Consultation Response from KC, Highways Development Management (HDM)

2024/91242 Land north east of Shepley Road, Stocksmoor, Huddersfield, HD4 6XW

Erection of residential development (up to 50 dwellings) with associated access, parking, public open space, landscaping and infrastructure

Date Responded: 14/10/24 | Responding Officer: A.Darwin | Responding Ref: 12-33/18

Access to the site is proposed via a new priority junction on Shepley Road, as shown on AMA drawing AMA/20547/SK002-P05. This access has been designed taking into consideration some of the concerns raised by HDM at the pre-application stage, and includes the following:

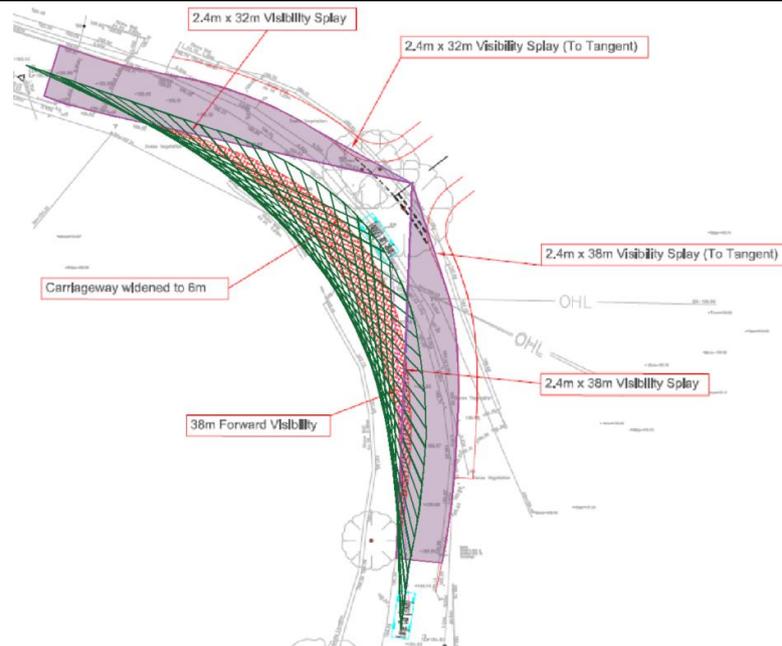
The principle of the site access arrangements are considered appropriate. However, there are a number of issues that need to be addressed before the arrangements can be accepted, which are as follows:

- Additional swept path analysis is required to confirm that a large vehicle (e.g. refuse vehicle) can pass a light vehicle on the widened bend (e.g. passing a stationary car waiting to turn right into the access). This may result in some additional carriageway widening being necessary (in addition to the widening to 6m as currently proposed). It is noted that Shepley Road is signed as being unsuitable for heavy vehicles. As such, passing by large vehicles will be infrequent and only a minimum level of clearance (e.g. 250-500mm) is expected to be demonstrated by this additional swept path analysis.

- The speed data included in the TA confirms that 85th percentile speeds on Shepley Road were recorded as 24.0mph southbound (e.g. exiting the village) and 27.5mph northbound (See section 4.2 of TA), and that the junction visibility splays and forward visibility splays at the bend have been provided in accordance with these speeds. However, following further information provided by the transport consultant who produced the TA, it has been confirmed that the speed survey was undertaken within the immediate vicinity of the site proposed access (e.g. on the apex of the bend) rather than on approach to the proposed junction. Therefore, the approach speeds to the junction may be slightly higher than those recorded by this speed survey. HDM have checked the detailed speed data results that also include approximate vehicle classifications, which suggest that the proportion of larger vehicles (e.g. OGV1, OGV2 and PSV) are at times over 10%. Therefore, the Stopping Sight Distance (SSD) should be based on a deceleration rate of 0.375g, rather than the 0.45g deceleration rate that has currently been used. Based on the higher recorded 85th percentile speed of 27.5m (northbound) and the deceleration rate of

0.375g, this equates to a SSD requirement of 41m. Therefore, in accordance with good practice, it is expected that the 41m SSD requirement is applied to all visibility splays at the junction and forward visibility around the bend, which should be clearly demonstrated on the plans.

- Some long section information has been provided in Appendix C of the TA, showing what appears to be the revised alignment of Shepley Road following the realignment works. This long section has then been used to seek to demonstrate that the visibility splay requirements are achieved vertically. However, the long section information is very limited in detail and does not include gradient or vertical alignment information to enable HDM to assess the feasibility of the proposals. It is noted that the gradient of Shepley Road (as amended by the revised alignment) within the vicinity of the site access should not exceed 1:12 within the full limits of the junction bellmouth and its immediate approaches, otherwise suitable crossfalls gradients on the site access minor arm are unlikely to be achievable (these should not exceed max. 4% as per the Highway Design Guide SPD). Based on HDMs check of the limited information provided on the long section, it appears that the site access may need to be relocated further to the west where the carriageway gradient would be reduced. Further level information is required, included detailed long section information on Shepley Road that clearly shows the proposed carriageway gradients, including tie-ins to the wider carriageway vertical alignment, together with more detailed vertical alignment/levels information within the minor arm of the junction to ensure that suitable crossfall gradients can be achieved.

- The proposed carriageway alignment on the southeast side of the bend appears to show the edge of the proposed carriageway immediately adjacent to the highway boundary. This should be amended to ensure that min. 600mm clearance is maintained.

- Block paving has been proposed in the inside of the realigned bend to protect the forward visibility splay envelope. The provision of a hard paved surface is welcomed, which should ensure that adequate visibility is maintained. However, a tarmac surface is likely to be preferred, to reduce the costs of future maintenance. The final detail of the paving type could be agreed at the S278 detailed design stage. However, the current paving proposals taper down to nothing at either end, which is not appropriate, and should be amended to provide to a minimum width of 600mm and include edging kerbs.

- It is expected that improved signage and road markings are provided at the 30mph/NSL transition to the south of the site access, which should include a replacement 30mph roundel and improved terminal signage on yellow backing boards. These should be shown on the proposal plans.

- Dropped pedestrian crossings with tactile paving should be provided at the site access, which should be shown on the plans. It should also be confirmed that adequate gradients are achieved at the crossing points.

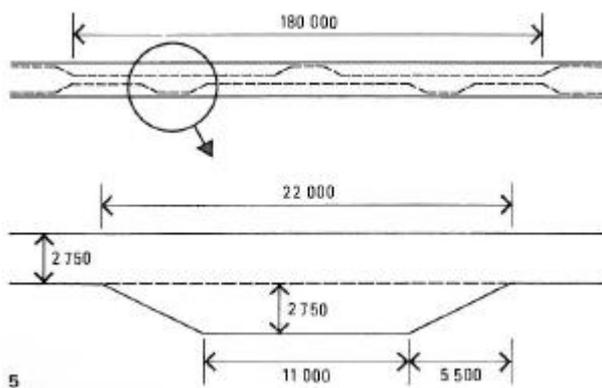
The applicant has not proposed any improvements to Stone Wood Lane as part of the proposals to address the existing deficiencies, and has sought to down play the problems by suggesting that development users are unlikely to use this route to access facilities in Shepley, and would instead travel the longer route to Shepley via Thunderbridge. HDM do not accept this (see further comments below regarding the traffic assessment) and consider the intensification of use of this route would adversely affect it's operation, both for drivers, but more importantly for pedestrians and cyclists (on this NCN route), who would be at increased risk of collisions with passing and reversing vehicles.

It is noted that HDM have undertaken multiple site visits along Stone Wood Lane, and on a number of occasions have encountered a vehicle approaching in the opposite direction. This has resulted in one of the drivers having to yield and then reverse back for a substantial distance to reach a point where vehicles can pass, at the sub-standard passing places that are available. This problem is then compounded when other vehicles arrive during these occurrences. Depending on the locations where vehicles meet, this can require multiple vehicles to reverse

back beyond the first informal passing point they reach, as there is insufficient space for the other vehicle to pass multiple vehicles.
